SUBJECT:		No:	SR-04-003
TIRE AND LOADING INFORMATION LABEL — SAFETY RECALL CAMPAIGN		DATE:	April, 2004
		MODEL:	See below
CIRCULATE TO:	<input checked="" type="checkbox"/> GENERAL MANAGER	<input checked="" type="checkbox"/> PARTS MANAGER	<input checked="" type="checkbox"/> TECHNICIAN
<input checked="" type="checkbox"/> SERVICE ADVISOR	<input checked="" type="checkbox"/> SERVICE MANAGER	<input checked="" type="checkbox"/> WARRANTY PROCESSOR	<input checked="" type="checkbox"/> SALES MANAGER

The Tire and Loading Information Label on affected vehicles states the incorrect vehicle capacity weight. If a customer wishes to have the dealer install the label, follow the instructions in this bulletin.

2004 Montero and Montero Sport vehicles produced before 1/29/04

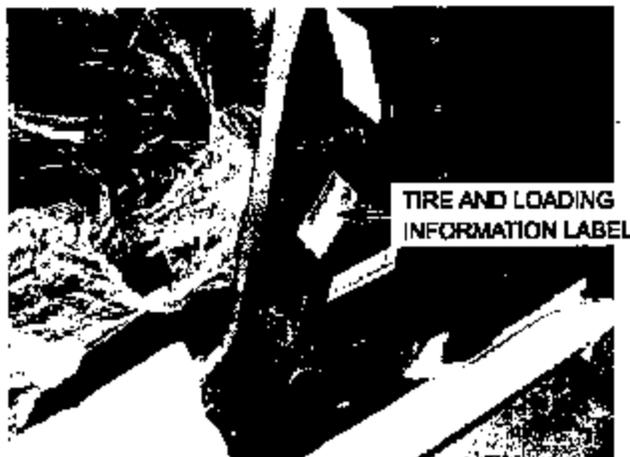
1. Remove the clear film from the original Tire and Loading Information label, located on the driver's side B pillar.

2. Affix the provided new Tire and Loading Information label over the original label.

MONTERO SPORT				MONTERO			
 TIRE AND LOADING INFORMATION				 TIRE AND LOADING INFORMATION			
SEATING CAPACITY		TOTAL 3	FRONT 2	REAR 3		SEATING CAPACITY	
		TOTAL 7	1ST 2	2ND 3	3RD 2		
The combined weight of occupants and cargo should never exceed 380 kg or 850 lbs.				The combined weight of occupants and cargo should never exceed 495 kg or 1091 lbs.			
ORIGINAL TIRE SIZE		COLD TIRE INFLATION PRESSURE		ORIGINAL TIRE SIZE		COLD TIRE INFLATION PRESSURE	
P255/70R18		FRONT	180kPa, 26PSI	265/70R16		FRONT	200kPa, 29PSI
		REAR	180kPa, 26PSI			REAR	200kPa, 29PSI
PART NO. 7430A137 B				PART NO. 7430A128
